Access Compliance Report

Public Rights-of-Way

(Curb Ramps)

Intersection ID: 2729	Main Street: FAIRVISTA_DR	Cross Street: FAIRWAY_POINT_DR	Location: NW
ADA ID: CF544487512A	Ramp Type: PerpDiag	Initial Pass/Fail: Fail	Overall Compliance: No
		Severity Score: 10

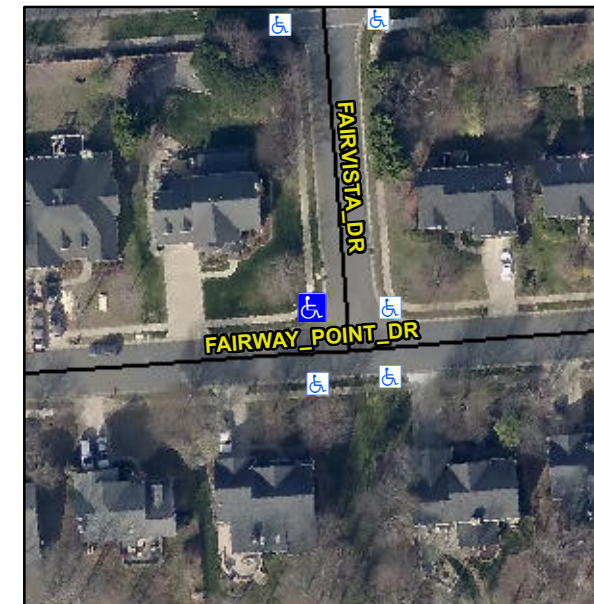
Not Found, R304.5.1, R304.5.3

Compliance	Description	Data	Compliance	Description	Data
N/A	Ramp Length (in)	50.0	Yes	Ramp Slope (%)	8.0
No	Ramp Width (in)	36.0	No	Ramp XSlope (%)	2.5
N/A	Flare Type LT	N/A	N/A	Flare Type RT	N/A
N/A	Flare Slope LT (%)	N/A	N/A	Flare Slope RT (%)	N/A
N/A	Flare Traversable LT?	N/A	N/A	Flare Traversable RT?	N/A
N/A	Landing Length (in)	N/A	N/A	DWS Provided?	N/A
N/A	Landing Width (in)	N/A	N/A	DWS Contrast?	N/A
N/A	Landing Slope (%)	N/A	N/A	DWS Length (in)	N/A
N/A	Landing X Slope (%)	N/A	N/A	DWS Full Width?	N/A
N/A	Landing Curb? (Y/N)	N/A	N/A	DWS Offset (in)	N/A
N/A	Shared Landing?	N/A			
N/A	Gutter Ponding?	Yes	N/A	Gutter Slope (%)	N/A
N/A	Gutter Lip Ht (in)	N/A	N/A	Gutter X Slope (%)	N/A
N/A	Painted X Walk1?	No	N/A	Painted X Walk2?	No
	X Walk 1 Direction	To S		X Walk 2 Direction	To E
N/A	X Walk 1 Width (in)	N/A	N/A	X Walk 2 Width (in)	N/A
	X Walk 1 Slope (%)	5.9		X Walk 2 Slope (%)	0.7
	X Walk 1 X Slope (%)	1.5		X Walk 2 X Slope (%)	1.4

Remove & Replace Curb Ramp With Two New Directional Ramps or Equivalent.
